Docket No. 50-423  
B15077

Millstone Nuclear Power Station, Unit No. 3

Proposed Revision to Technical Specifications  
TSP Baskets

Attachment 2  
Millstone Nuclear Power Station, Unit No. 3  
Proposed Revision to Technical Specifications  
TSP Baskets  
Radiological Dose Calculation Assumptions and Results

FIGURE 1

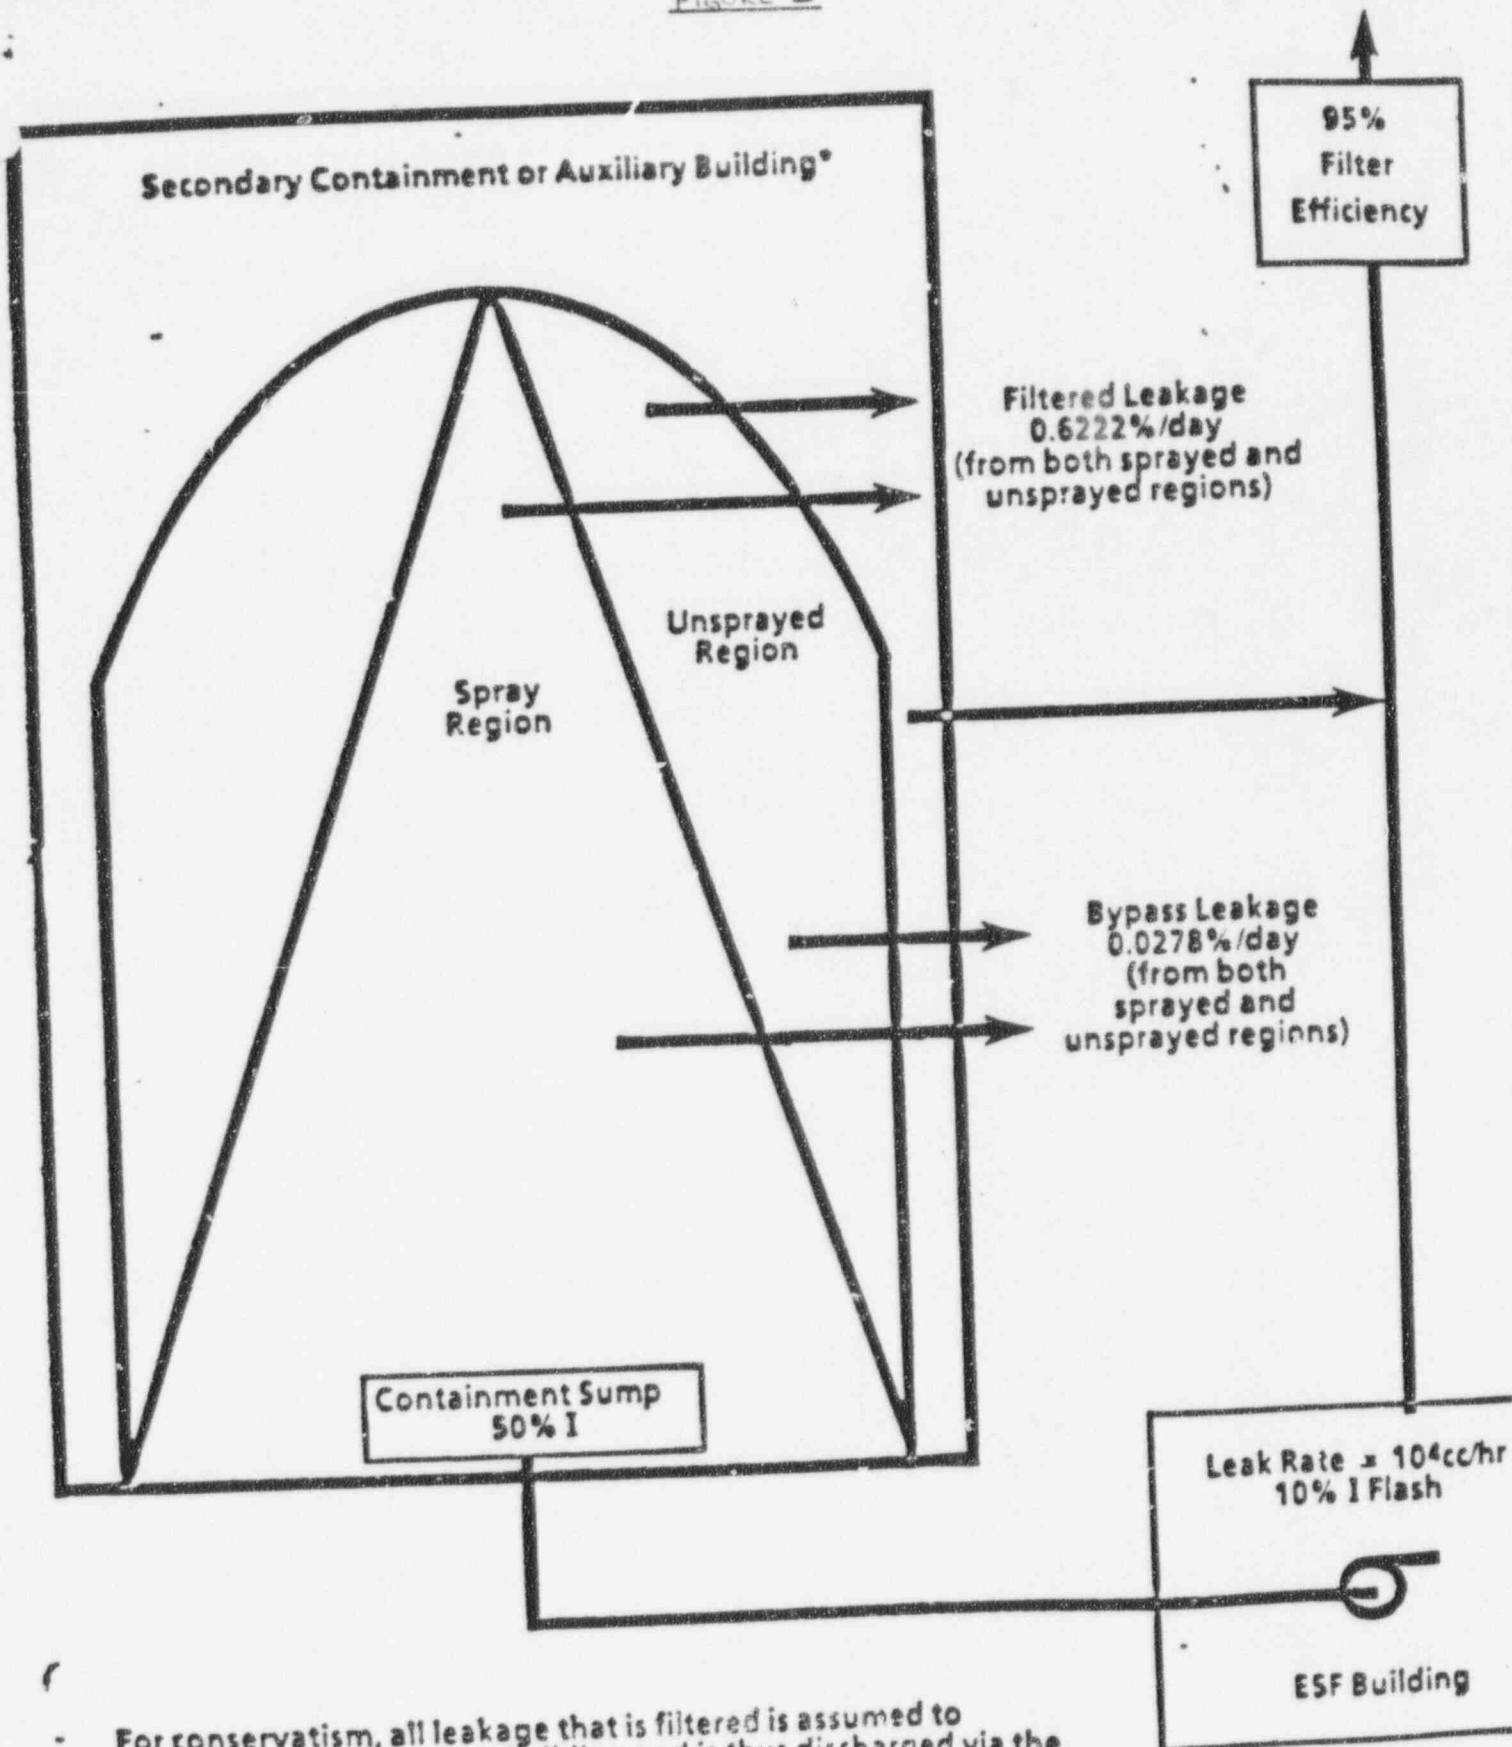
Figure 1 shows the assumed release pathways for the loss of coolant accident (LOCA) dose calculation. There are three release pathways analyzed: (1) containment leakage into the secondary containment which is filtered and released via the ventilation vent, (2) containment leakage that bypasses the secondary containment and is released unfiltered at the ground level, and (3) ESF leak which is filtered and released from the ventilation vent. The radiological doses are calculated separately and then added. The assumption for each pathway are provided in Tables 1, 2, and 3, respectively. Table 4 presents the assumptions associated with the iodine removal from containment atmosphere by the containment spray systems. Table 8 provides the results of the dose calculations.

For conservatism, all leakage that is filtered is assumed to originate in the Auxiliary Building and is thus discharged via the ventilation vent. Leakage into the secondary containment would go to SLOKS and to Unit 1 stack. MP1 stack releases would result in lower doses.
